# City of Portland Design Commission

## Design Advice Request

### SUMMARY MEMO

**Date:** January 18, 2019  
**To:** Li Alligood, Otak, Inc.  
**From:** Arthur Graves, Design Review  
503.823.7803 | [Arthur.Graves@portlandoregon.gov](mailto:Arthur.Graves@portlandoregon.gov)  
Bureau of Development Services | Portland, Oregon  
**Re:** EA 18-210300 DA – 350 NW 12<sup>th</sup> Avenue | Hyatt Place  
Design Advice Request Commission Summary Memo – January 03, 2019

# HYATT PLACE | DESIGN ADVICE REQUEST 2 | ELEVATIONS

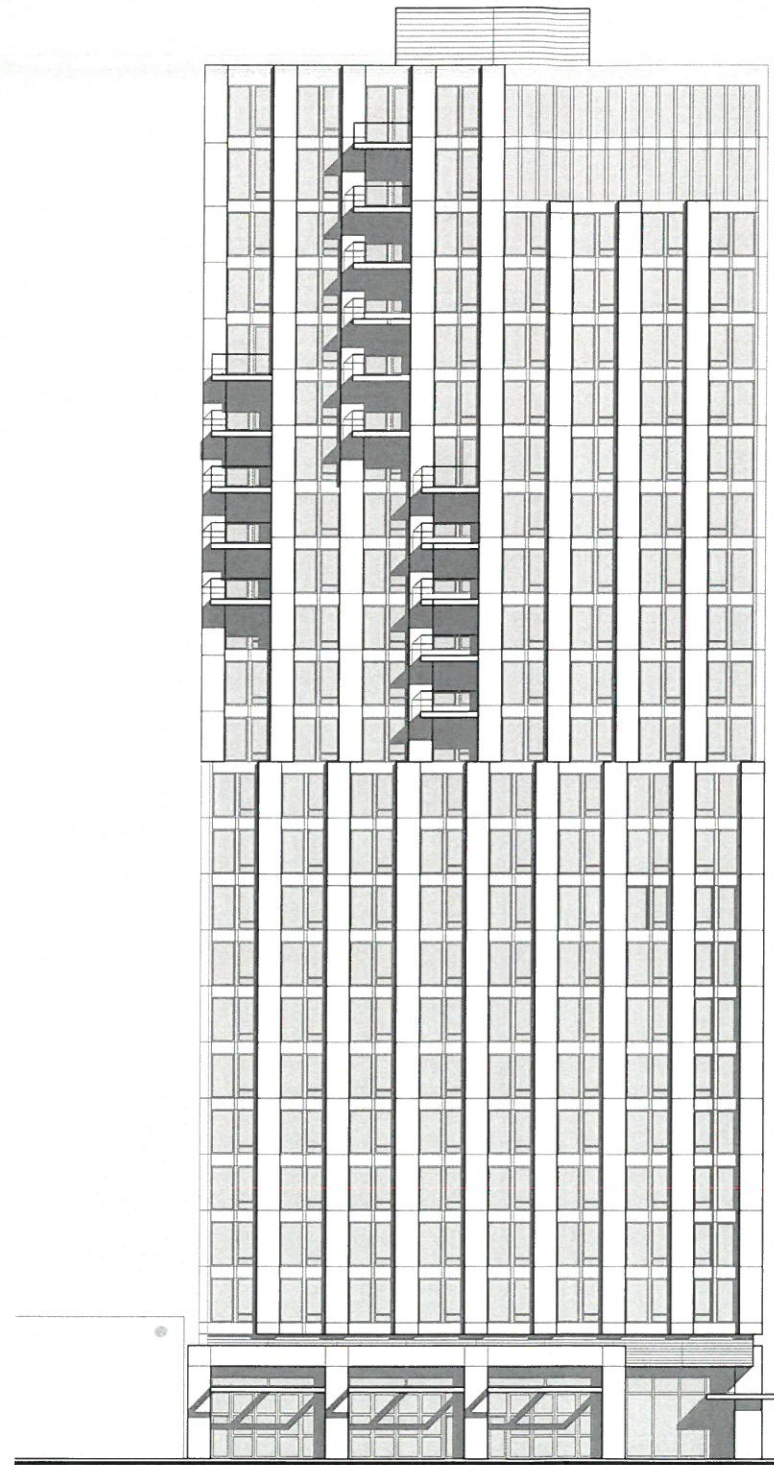
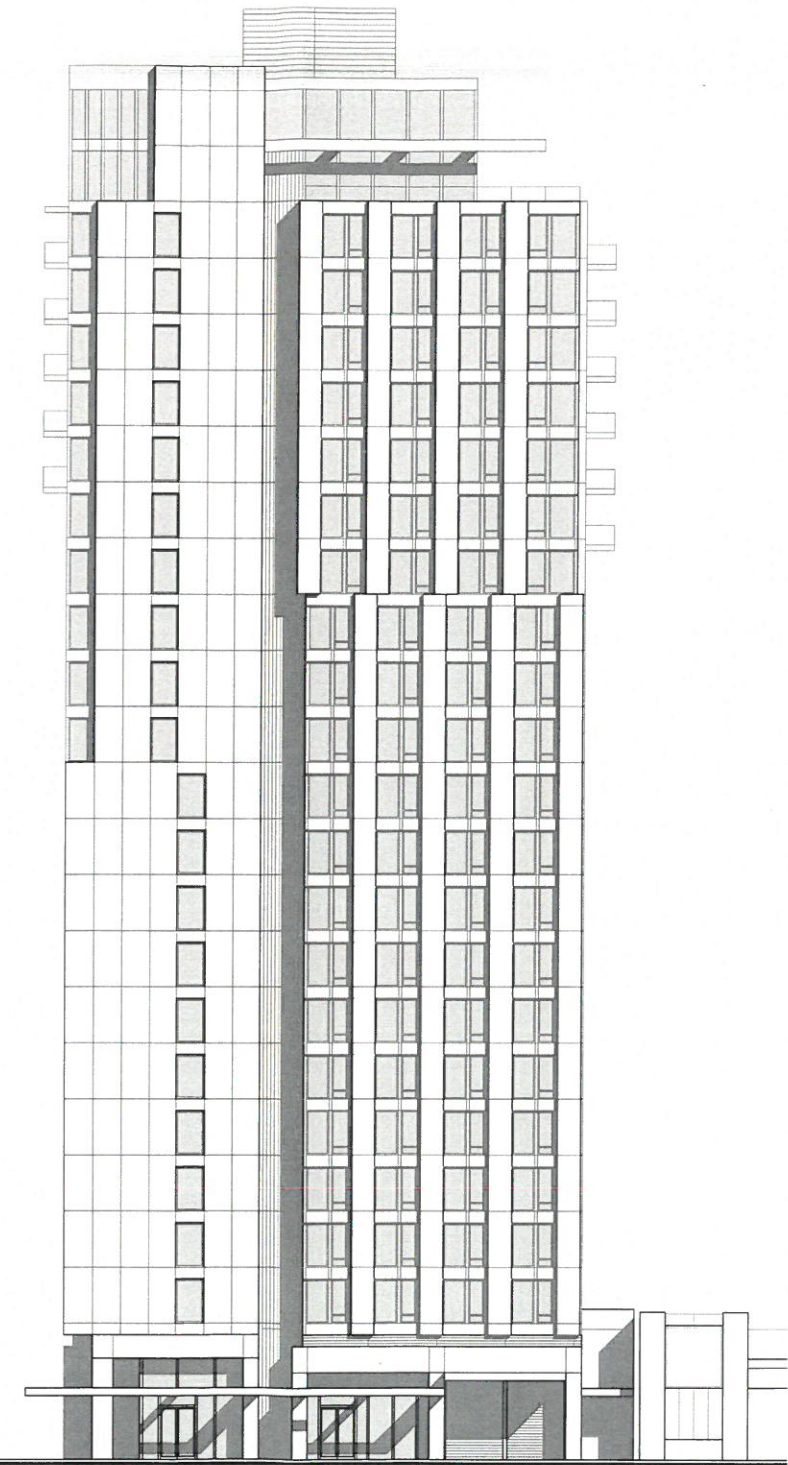
1. **Massing:** The Commission requested further study and development of the massing and sculpting of the proposal. The Commission agreed that further architectural response to the surrounding context and Historic District is needed. One Commissioner stated an alternative to eroding the mass of the building as the sculptural move and instead suggested that the sculptural move could be accomplished with one decisive move, the example of the Cayan Tower ("twisting tower") was mentioned. One Commissioner stated that the current design was very "blocky" and suggested that through increased integration of the balconies the articulation and sculpting of the building would appear thinner and less massive.

- b. **Top of tower.** The Commission agreed that the top of the tower should have increased sculpting, articulation and a clear termination to be a more complete composition. Commissioners agreed that the proposed lantern effect is consistent with the district. One Commissioner requested that the tower as it is designed on the southwest corner be brought around to the other elevations.

- c. **End wall.** The Commission felt that the end walls were successful and more dynamic than the current street facing facades. Commissioners stated that the end walls should include as much glazing as is feasible. One Commissioner stated that the end walls were not cohesive regarding current upper story and lower story design.

# HYATT PLACE | DESIGN ADVICE REQUEST 2 | LEVEL 01 - PLAN

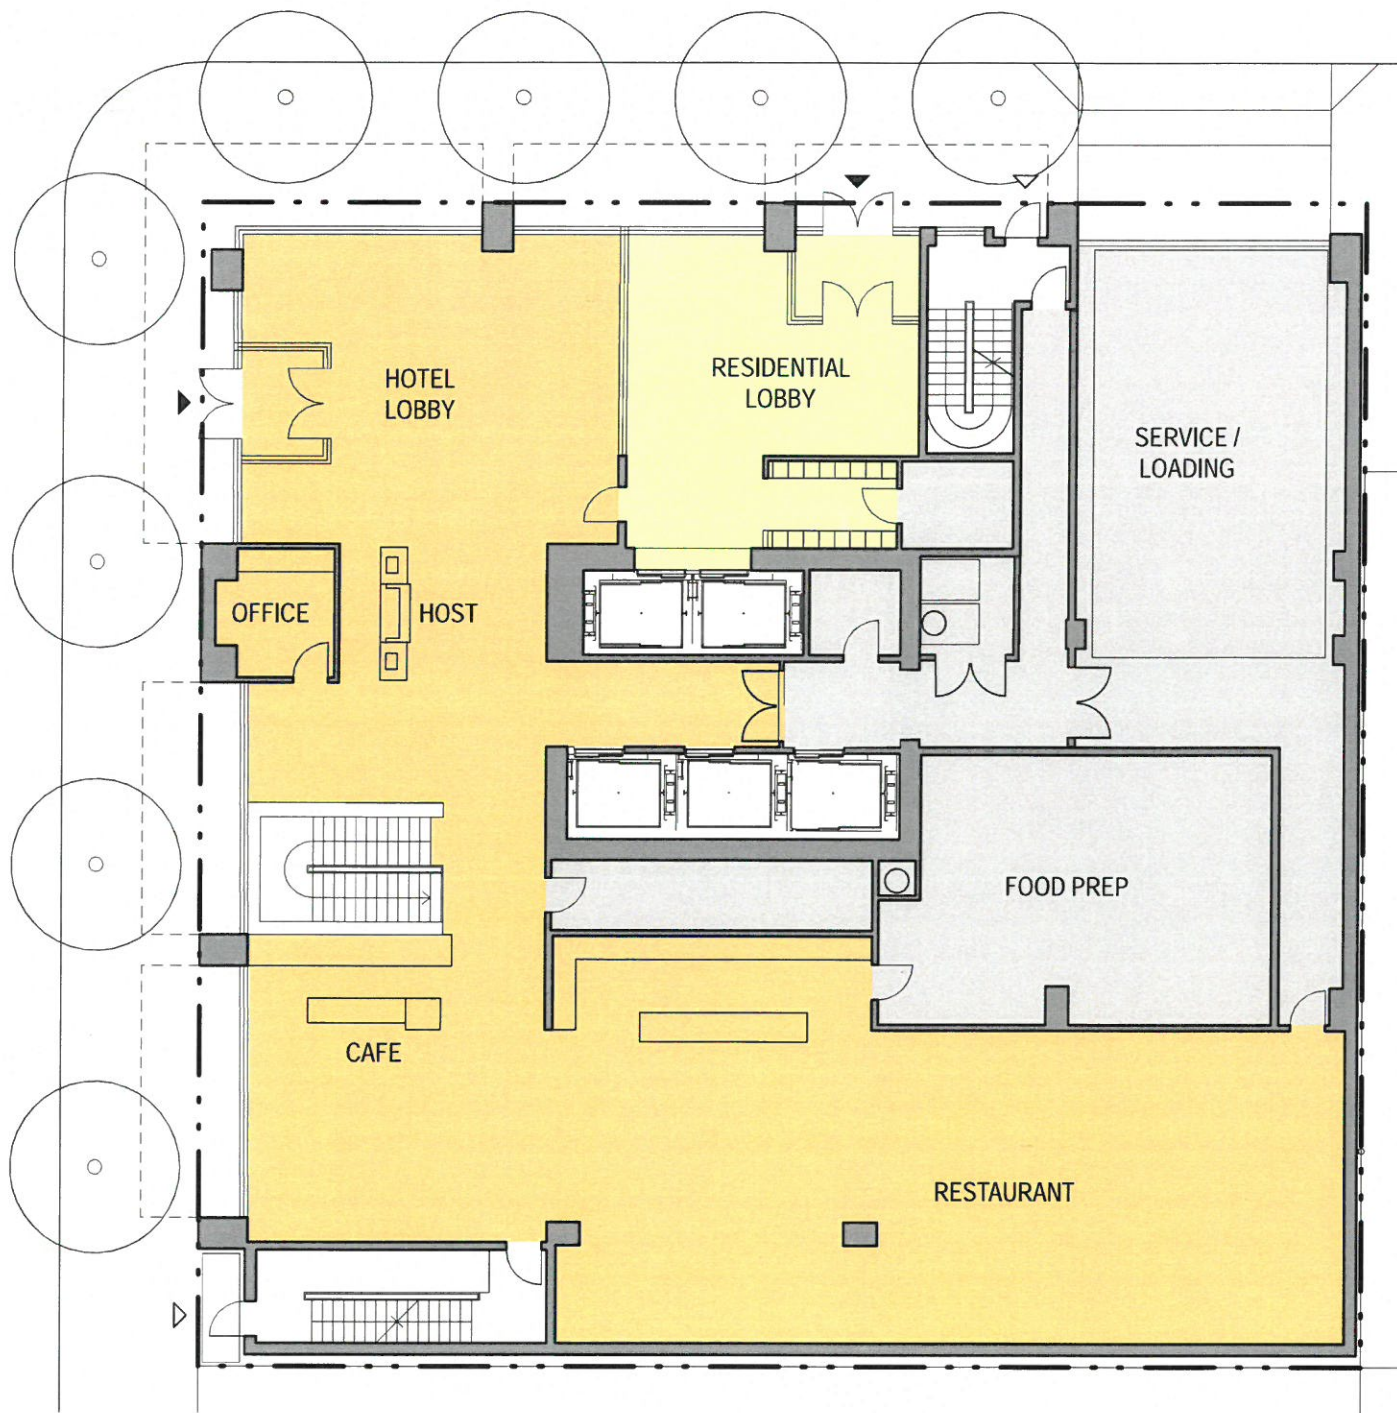
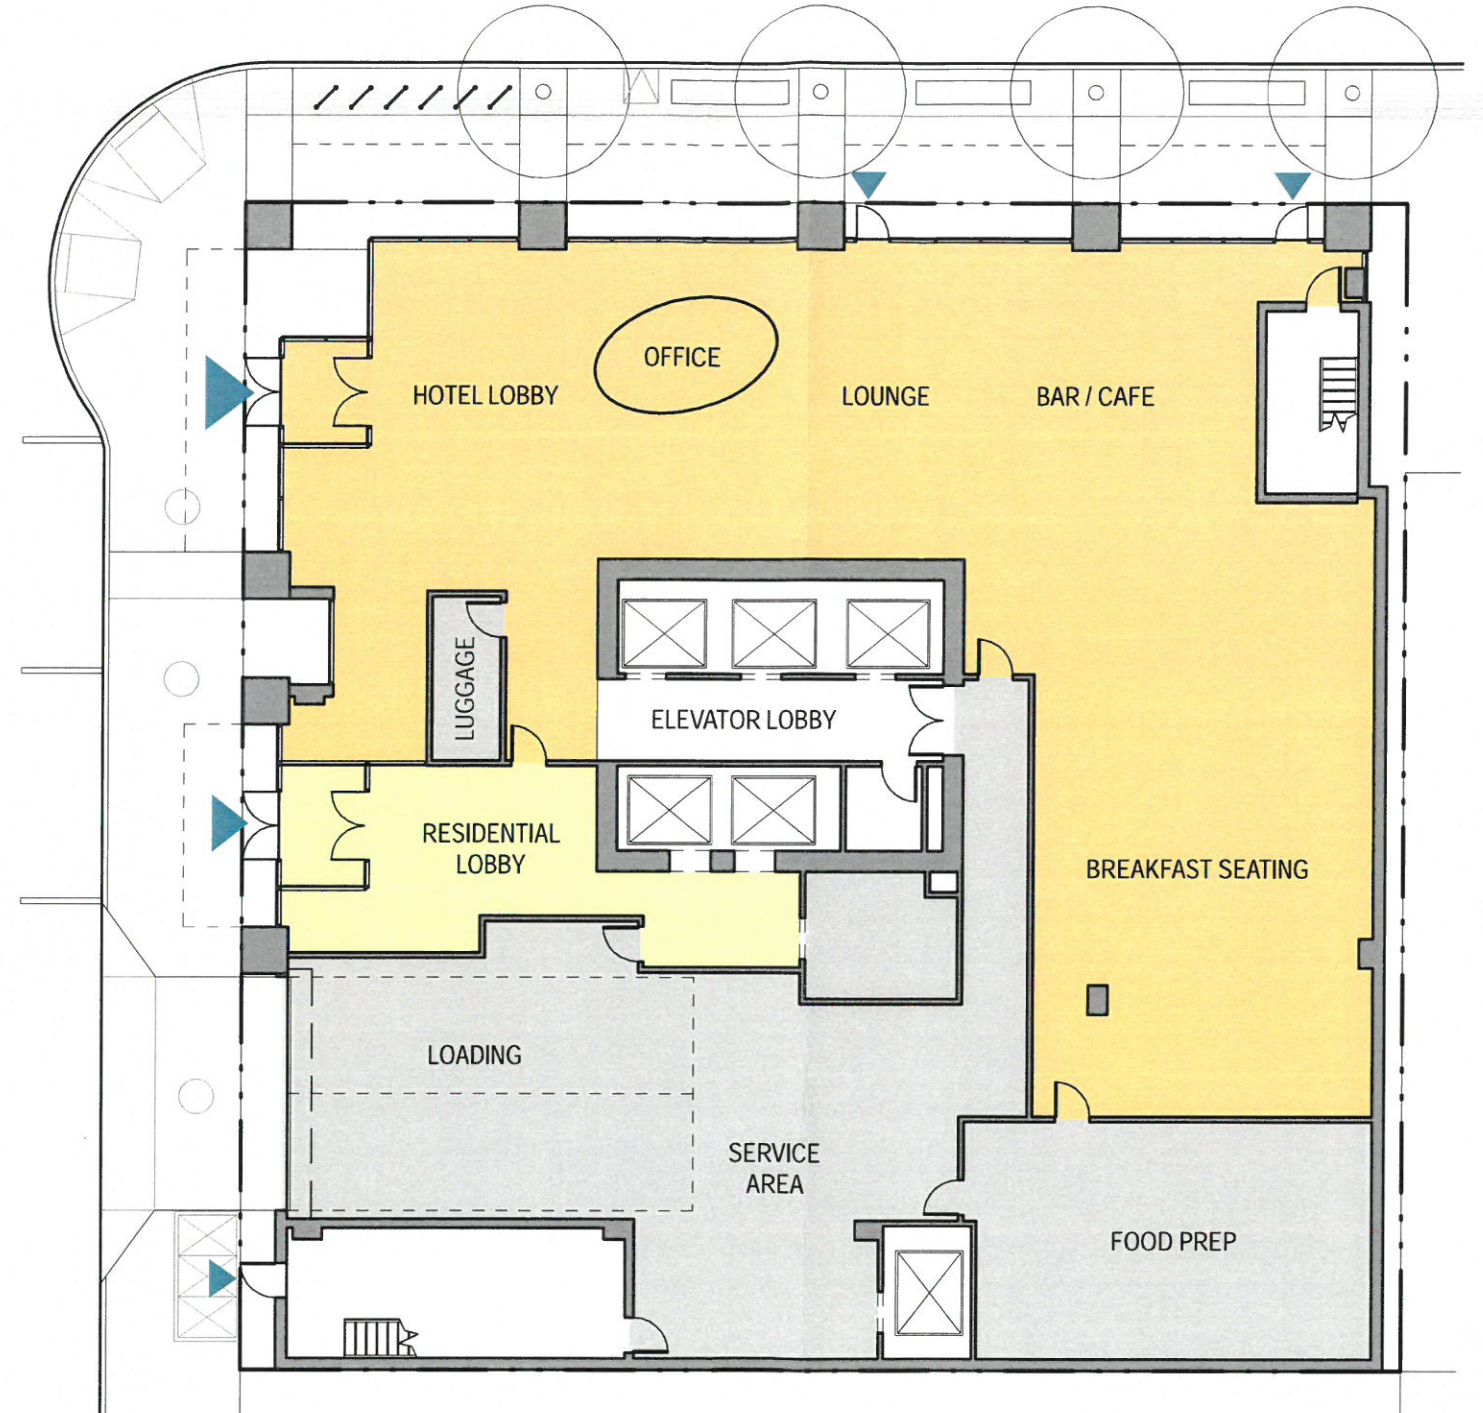
1. **Loading location:** The Commission supported locating the loading off NW 12<sup>th</sup> Avenue.

3. **Entrances and Hierarchy:** The Commission generally supported the proposed first floor organization. Several Commissioners noted that the proposed entrances needed additional study: hotel access off NW Flanders Street, residential access off NW 12<sup>th</sup> Ave, etc. Commissioners agreed that this refinement would help to provide an improved hierarchy to the ground floor. Commissioners supported the proposed canopies but requested additional refinement in their location for continuity and hierarchy to ground floor use.

4. **Bicycle Access:** The Commission agreed that the current bicycle access is problematic in size and location.
5. **Art and water features:** A response to the design guidelines related to public art, water features, and the incorporation of Portland themes, must be responded to. The Commissioners requested that these elements be architecturally integrated. As stated in the first DAR, several Commissioners stated that the thoughtful incorporation of these elements could help the project provide a contextual response to the neighborhood.
